City of Keene Planning Board

AGENDA

MEMORANDUM - AMENDED

GRAVEL AND EARTH REMOVAL PLAN

Fig 2: Proposed land to be transferred

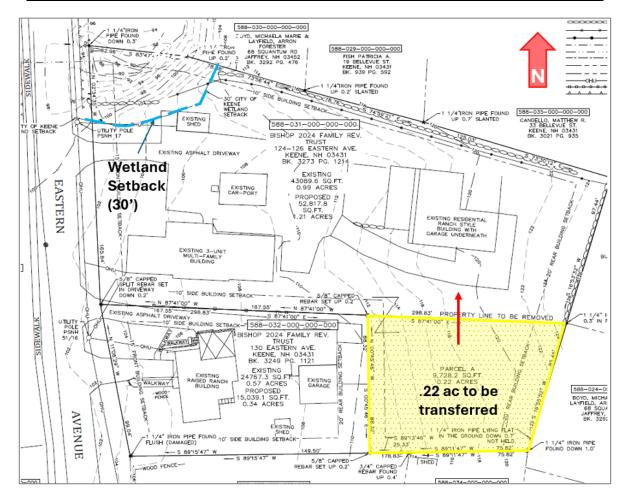
<u>SECTION 20.2.1 – LOTS:</u> The applicant proposes to transfer \sim 0.22 ac of land from the \sim 0.57 ac parcel at 130 Eastern Ave to the \sim 0.99 ac parcel at 124-126 Eastern Ave. Following this transfer of land, both parcels will still comply with the zoning dimensional requirements for the Low Density District, as shown in Table 1. This standard appears to be met.
